PTUA Geelong Branch
PO Box 4127
Geelong Victoria 3220
www.ptua.org.au/geelong

SUBMISSION TO GEELONG RING ROAD SECTION 4C ADVISORY COMMITTEE

Armstrong Creek Structure Plan, 2006

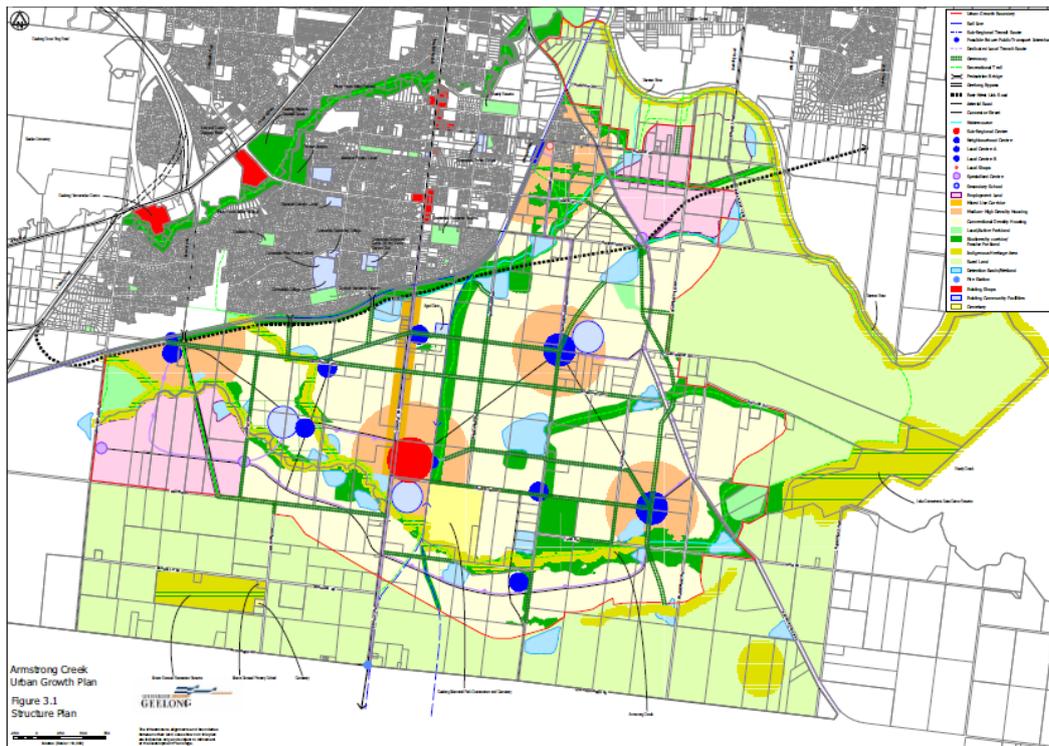
Although we were concerned that the corridors provided in the 2006 plan did not allow easy walking access to public transport from all parts of the estate, their presence did show that public transport routes were an important consideration, and that public transport was to be given priority by being separated from other road traffic.

The purple lines on the map are the dedicated public transport corridors.
